PLANNING DIVISION STAFF REPORT

March 24, 2014

Project Address: 1406 Mound Street, 116 and 120 South Randall Avenue
Application Type: Demolition and Conditional Use
Legistar File ID #: [33076](#)
Prepared By: Heather Stouder, AICP, Planning Division
Report Includes Comments from other City Agencies, as noted

East Elevation, Original Submittal (brick base and limestone element in center of facade, matching existing building materials)

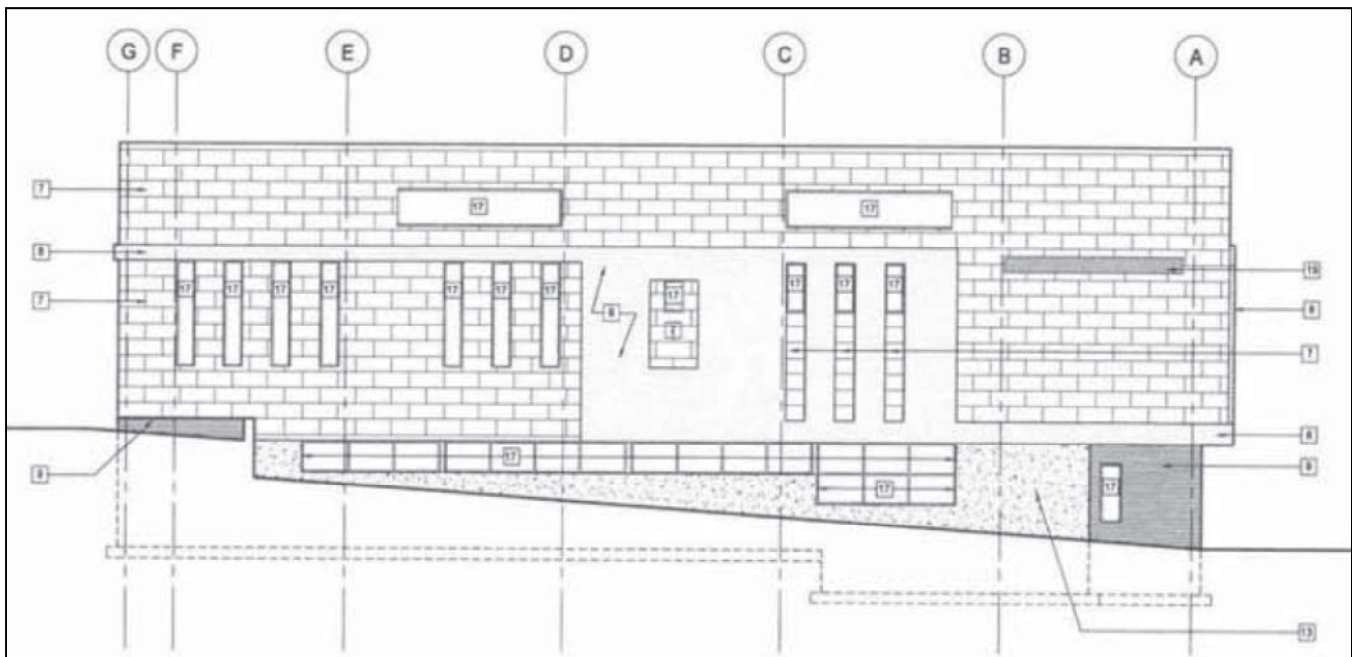
Staff believes that this standard can be met, but recommends that the applicant return to the originally proposed palette of materials (brick base and limestone accent wall) on the east side of the building, consistent with the materials on the rest of the building. Staff believes that the continuity of the brick base is especially important as a way to tie the primarily metal addition to the rest of the building. Otherwise, along South Randall Avenue, the primarily metal addition would maintain little continuity with the existing building. Staff understands that the applicant opposes this recommendation due to cost and other implications to the project.

1. Final plans submitted for staff review and approval shall include a detailed schedule of proposed materials, including color specifications. On the South Randall Avenue elevation, the applicant is encouraged to replace the proposed sandblasted concrete base with brick to match the rest of the building base, and also to replace the exterior plaster with limestone, as was originally proposed.
